PRELIMINARY PLAN M-NCPPC No. 120170180

4100 JONES BRIDGE ROAD  
PARCEL 976  
HAYES  
PROPOSED FIVE LOT SUBDIVISION (A-E)  
PRELIMINARY PLAN

Re: **CAS Job No. 16-176**  
**4100 Jones Bridge Road, Chevy Chase, MD 20815**  
**Parcel 976, Hayes, Tax Map HP341 & HN343**  
**Preliminary Plan #: 120170180**  
**Forest Conservation (Chapter 22A) Variance Request - Revised**

RE: Preliminary Plan No. 120170180  
Hayes

# PRELIMINARY PLAN M-NCPPC No. 120170180

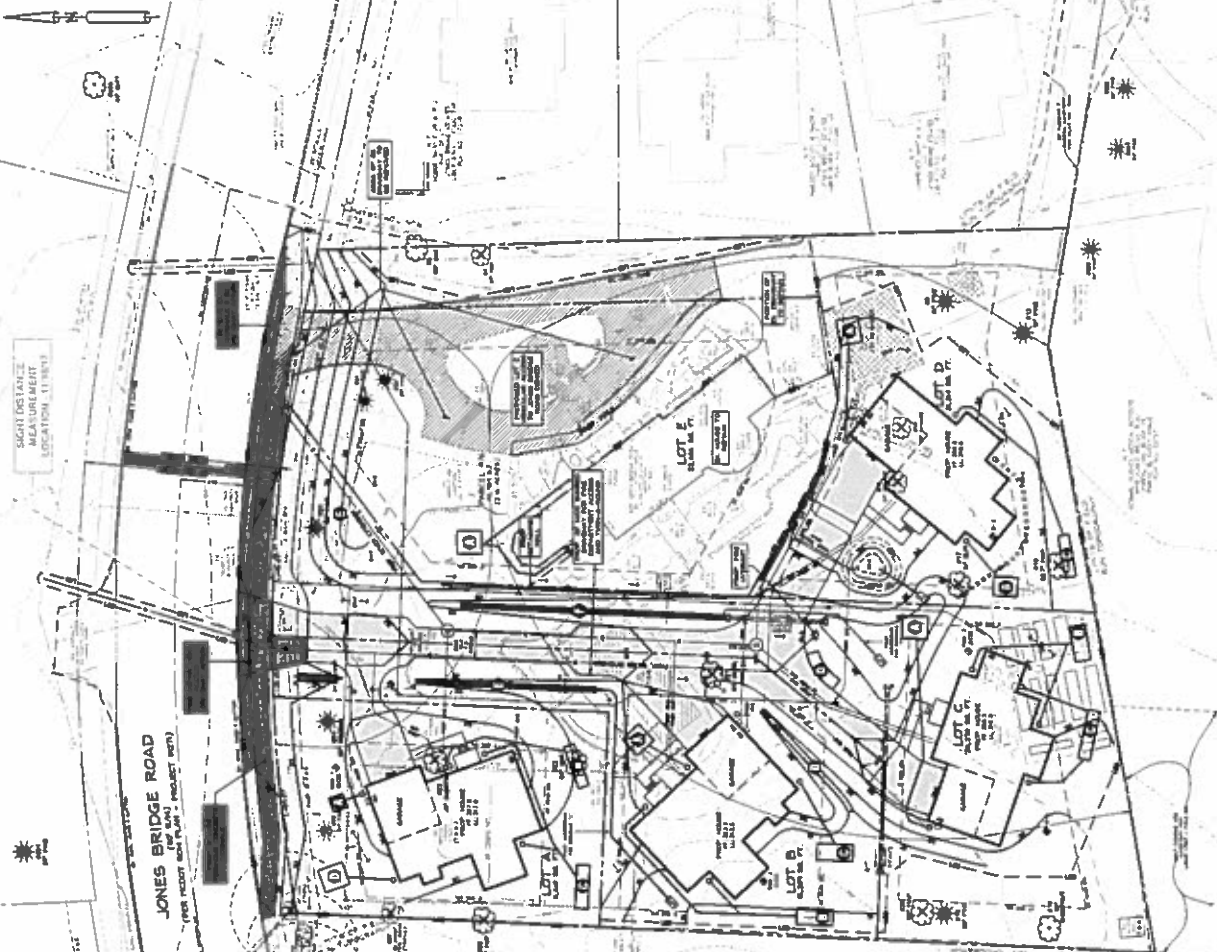
We have completed our review of the preliminary plan dated March 20, 2017. A previous plan was reviewed by the Development Review Committee at its meeting on February 7, 2017. We recommend approval of the plan subject to the following comments:

1. Grant necessary slope easements. Slope easements are to be determined by study or set at the building restriction line.
2. The storm drain analysis was reviewed and is acceptable to MCDOT. No improvements are needed to the downstream public storm drain system for this plan.
3. We have reviewed the consultant's March 7, 2017, revised Sight Distance Evaluation and proposed regrading exhibit for the relocated private shared common driveway. We find the consultant's concept and estimated sight distance to be plausible. However, we are unable to approve the new Certification Form at this time – since the regrading and removal of obstacles have not yet been completed.

Prior to DPS release of the right-of-way construction and site access permits for this project, the consultant will need to submit an updated Sight Distances Evaluation Certification Form for the proposed driveway – based on actual field measurements – which indicates regrading, tree trimming and/or removal of obstacles have been completed to achieve a minimum of three hundred twenty five (325) feet of visibility in each direction.

4. Record plat to reflect a reciprocal ingress, egress, and public utilities easement to serve the lots accessed by the proposed common driveway.
5. Private common driveways and private streets shall be determined through the subdivision process as part of the Planning Board's approval of a preliminary plan. The composition, typical section, horizontal alignment, profile, and drainage characteristics of private common driveways and private streets, beyond the public right-of-way, shall be approved by the Planning Board during their review of the preliminary plan.

6. Provide a ten (10) foot wide Public Utility Easement (PUE) along the Jones Bridge Road street frontage.
7. Relocation of utilities along existing roads to accommodate the required roadway improvements shall be the responsibility of the applicant.

## FIRE DEPARTMENT ACCESS PLAN

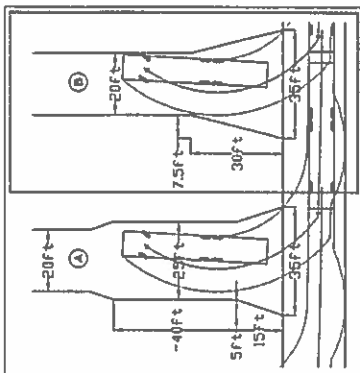
In accordance with Executive Regulation 8-16, Fire Safety Code – Building Construction, we hereby request an approval under the application of performance based design for the attached Fire Department Access Plan.

Section 18.2.3.4.1.1.1 states, "Fire Department apparatus access must be 20 feet wide, unless specifically excepted in this Regulation, or as approved by the Director." As proposed on the Fire Department Access Plan the required 20-ft wide Fire Department Apparatus Access is reduced to a through access width between the entrance and turnaround. An additional water supply is provided beyond the through access section of the Fire Department access road and located at the dead-end apparatus turnaround.

**\*\*\* 11/21/2017 Approval of revised plan - See Statement of Performance Based Design regarding modified driveway \*\*\***

SHARED DRIVEWAY APPROVED  
2018-01-01
